Assessment of Proposed Calibration Support for the Analog Instrumentation Functions in the Integrated Family of Test Equipment (IFTE) Systems

Prepared for: U.S. Army TMDE Support Activity Redstone Arsenal, AL 35898-5400

NISTIR 4955 For Official Use Only

Final Report

Figure 3. Errors caused by two-point (0 and 18 V) alignment procedure of the DMM on the 100 V range

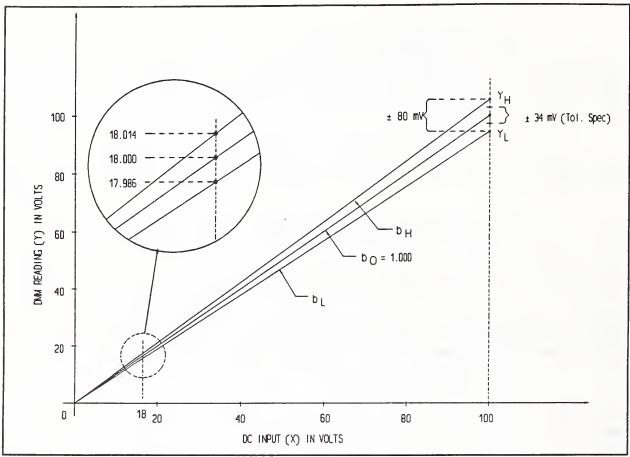
The bigger issue on these ranges is the use of an 18 V reference point as a means of correcting gain error, since 18 volts is only 18% and 6% of full scale, respectively, on the 100 V and 300 V ranges. As shown in figure 3, using the 18 V reference, the worst-case measurement error on the 100 V range is approximately 14 mV (neglecting the error in the 18 V reference):

Thus, the DMM could have nearly a ± 80 mV error band rather than the ± 34 mV expected from the specification tolerance, calculated as

Figure 4. Measured error of IFTE counter-timer vs. period

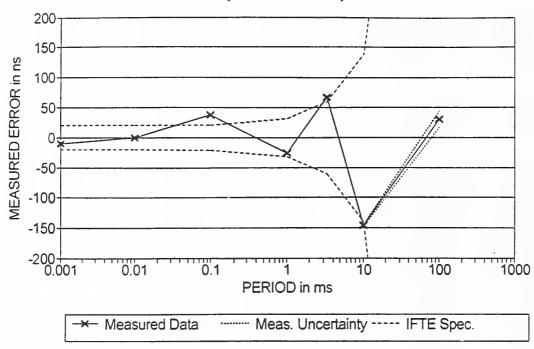
Figure 4 shows the error of the IFTE counter-timer in nanoseconds, plotted as a function of the period in ms, relative to the reference time-interval counter. The IFTE specification for the accuracy of the counter-timer is also graphed in figure 4, based on the time measurement accuracy specification of ±10 ns ±1 count ± time-base error [17]. Since the specification is unclear as to what the ±1 count applies to (full-scale range, reading, etc. - see section 5.1.5), the time error used for this term was the largest value of either 10 ns (the resolution of the counter-timer) or 1 part in 108 of the period (based on the specified "84 digit" display). If a 10 s integration time is used to obtain the maximum resolution, then the internal 10 MHz clock will produce 100 000 000 counts. Because of the specified 12 ppm time-base (clock) maximum error, the uncertainty in this count can be as much as 1200 counts. To convert the total count into a corresponding period, the decimal point in the period display (normally positioned at 10.0 000 000) is moved n places to the left, where 10ⁿ is the number of periods of the signal that are averaged in order to get the full 10 s resolution. For example:

Consequently, the IFTE specification is plotted as shown in figure 4. The uncertainty of the reference time-interval counter is barely discernable in the figure because it is so small relative to the vertical resolution of the graph, except between the 10 and 100 ms test periods.

Figure 6. Measured error of IFTE counter-timer vs. phase angle at 1 kHz

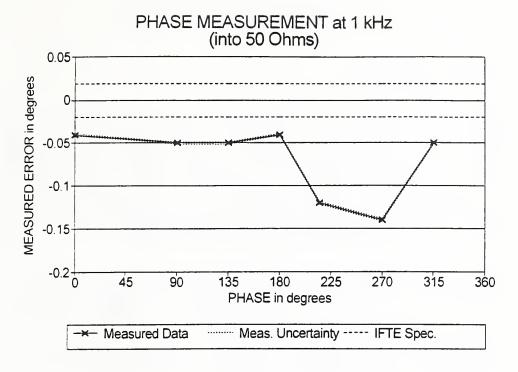
It can be seen from figure 6 that at 1 kHz the counter-timer badly failed to meet the IFTE specification over the whole range of phase measurements. Whereas the measured phase error is nearly the same from 0° to 180° (0.01° variation) as expected, the measured errors over the phase interval from 180° to 315° have a large 0.1° variation (-0.04° to -0.14°). This 0.1° kind of a discontinuity may be related to the same kind of unexplained large errors discussed above in section 6.2.2 on pulse-width measurements.

Figure 7. Measured error of IFTE counter-timer vs. phase angle at 100 kHz

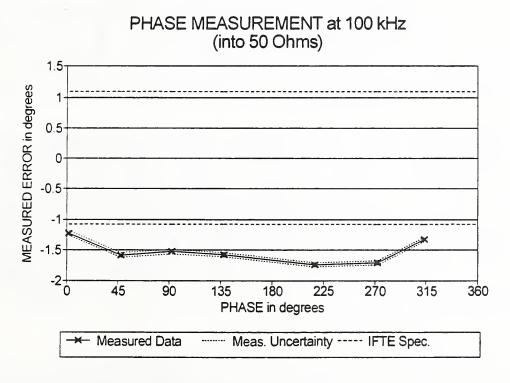
At the 100 kHz signal frequency (see figure 7), the measured error of the counter-timer again failed to meet the IFTE specification over the range of phase measurements taken, although not as far outside the specification limits as at 1 kHz. Also, the errors are nearly the same over the entire phase interval of the measurements, as expected. The larger errors at 215° and 270° may be due to similar large errors at these phase angles observed at 1 kHz in figure 6.

Figure 8. Measured error of IFTE digitizer vs. frequency for sine waves (V_{p-p})

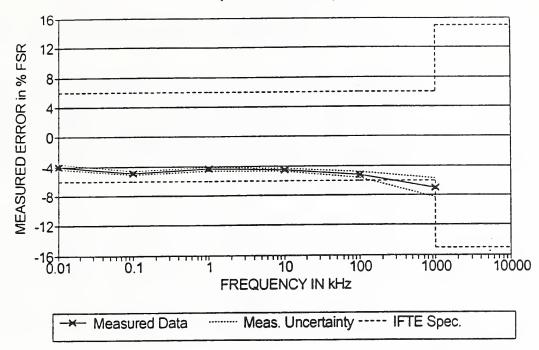
Figure 8 (2.0 $\rm V_{p-p}$ Sine-Wave Measurement) shows the measured error of the digitizer in making peak-to-peak measurements (deviations with respect to the reference DMM) in percent, relative to a full-scale input signal range (FSR) of 2.5 $\rm V_{p-p}$. Similarly, figure 9 (0.7 V RMS Sine-Wave Measurement) shows the measured error of the digitizer in making RMS measurements with respect to the reference DMM using the same FSR of 2.5 $\rm V_{p-p}$. The figures also show the IFTE specification based on $\pm 6\%$ of the FSR for all measurements up to the 1 MHz point, and $\pm 15\%$ of FSR for the 1 MHz point and higher [17].

The -4% offset is likely due to the resistive voltage drops of the connectors and Signal Distribution System (SDS) conductors internal to the IFTE station, ahead of the programmed 50 input termination of the digitizer. Supposedly, these offsets are corrected by running the digitizer self-alignment software, which applies the 0.9 V dc reference voltage from the SA-ICD to the digitizer, averages the readings, and subtracts the average from 0.900 volts to store a correction [7]. The rolloff of the response with frequency is also likely due to distributed capacitances in the connector/SDS paths to the digitizer, as reflected in the 50 MHz bandwidth specification. Consequently, the vendor's recommended procedure of using only a dc reference voltage from the SA-ICD to correct the digitizer amplitude readings (see section 5.2.3 above) probably needs to be further investigated and revised.
